## B.21 – ACCIDENTS AND MALFUNCTIONS

On January 27, 2015, the Executive Committee requested that CMC provide supplementary information to the Casino Project (YESAB Project No. 2014-0002) to enable the Executive Committee to commence Screening. The Executive Committee considered comments from various First Nations, Decision Bodies and regulators on the adequacy of the Project Proposal in the preparation of the Adequacy Review Report (ARR). CMC provided a Supplementary Information Report (SIR-A) on March 16, 2015. Subsequently, the Executive Committee issued a second Adequacy Review Report (ARR No.2) on May 15, 2015 following a second round of review.

Responses to the eight requests for supplementary information related to Section 21 and Section A.21 of the Project Proposal and SIR are provided below, as outlined in Table B.21.1-1. CMC is providing this Supplementary Information Report (SIR-B) to comply with the Executive Committee's Adequacy Review Report ARR No.2; CMC anticipates that the information in the two SIRs and in the Proposal, when considered together, is adequate to commence Screening.

**Figure B.21.2-1HHRA Conceptual Model for Noise Exposures**

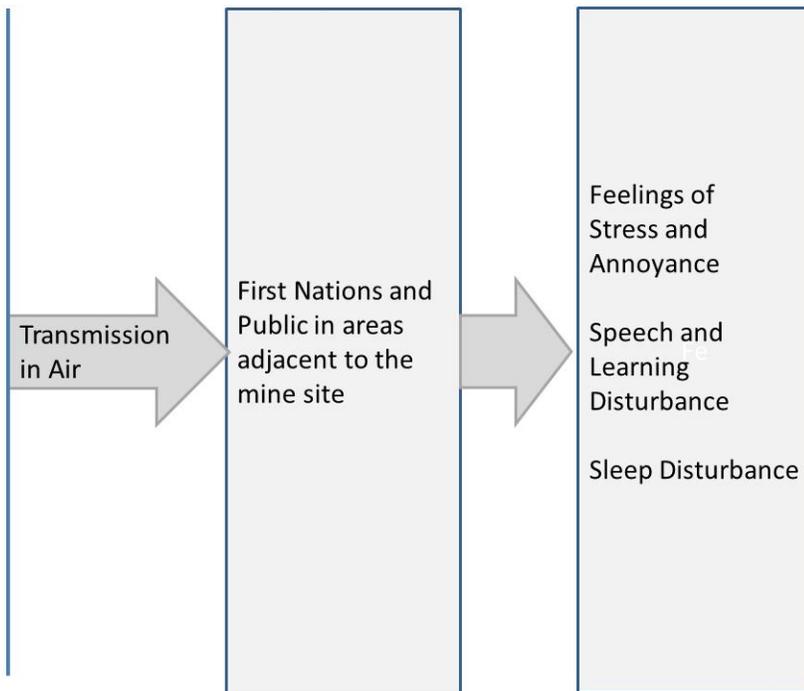
#### **R2-220. A human health risk assessment for the Project. Details should include:**

The conceptual model for the evaluation of human health risks associated with Project related noise is provided in Figure B.21.2-1. Human exposures to noise occur via airborne transmission of sound energies, as modelled in the noise assessment of the Project Proposal. Especially at or near the ground surface, noise transmission can be affected by masking from objects such as terrain or trees. The types of noise metrics that are used to formally and quantitatively assess health effects such as percent of an exposed sub-population that may experience feelings of being highly annoyed or sleep disturbance are generally available from the previously complete noise assessment (response to R444).
